GNRO-2012/00014

SUBJECT: Supplemental Information Pertaining to License Amendment Request for

Standby Liquid Control System (TAC No. ME7860)

Grand Gulf Nuclear Station, Unit 1

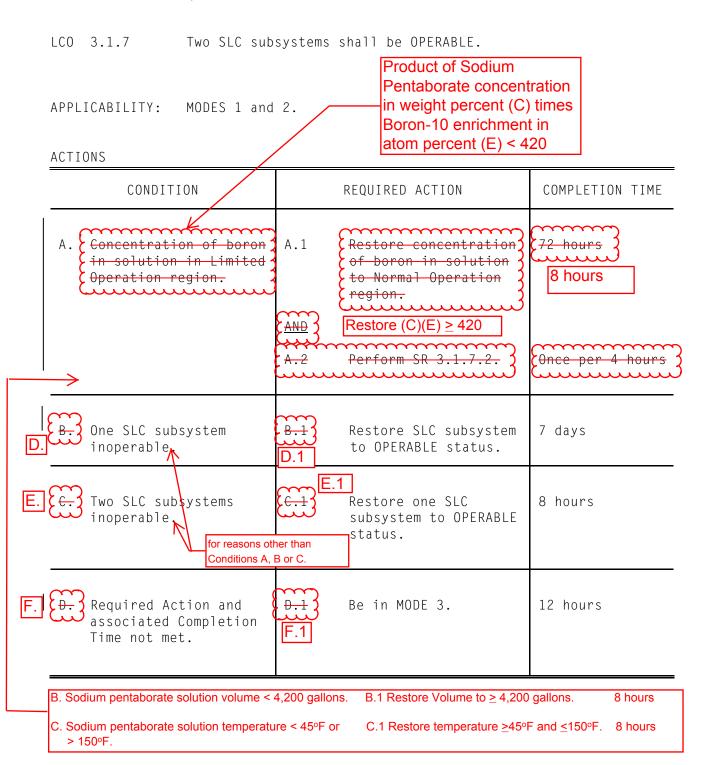
Please provide additional information pertaining to suppression pool pH control discussed in Section 4.1.3 of the SLC system LAR.

In Grand Gulf's license amendment application of NUREG-1465, *Accident Source Terms for Light-Water Nuclear Power Plants*, Entergy provided a method and associated calculation that showed the SPB solution from the SLC system was capable of controlling and maintaining long-term suppression pool water pH level at or above 7.0 throughout the entire 30-day period of a postulated accident. The NRC staff agreed with this determination, as documented in their Safety Evaluation for the amendment.<sup>3</sup>

Using the same methodology, Entergy has calculated the pH of the suppression pool water when enriched SPB is injected into the reactor core following an accident. This evaluation considered inputs that reflect extended power uprate conditions (i.e., operating at 4408 MWt), which are conservative to conditions when operating at the current licensed thermal power (3898 MWt). Furthermore, the calculation assumes approximately 1,400 lbs. of SPB is in the pool, which conservatively models the SLC storage tank solution at minimum volume and minimum concentration.

Thus, it can be concluded that injecting an amount of SPB solution required by the proposed TS to satisfy the shutdown requirement also is sufficient to maintain suppression pool pH greater than 7.0 for at least 30 days post-accident.
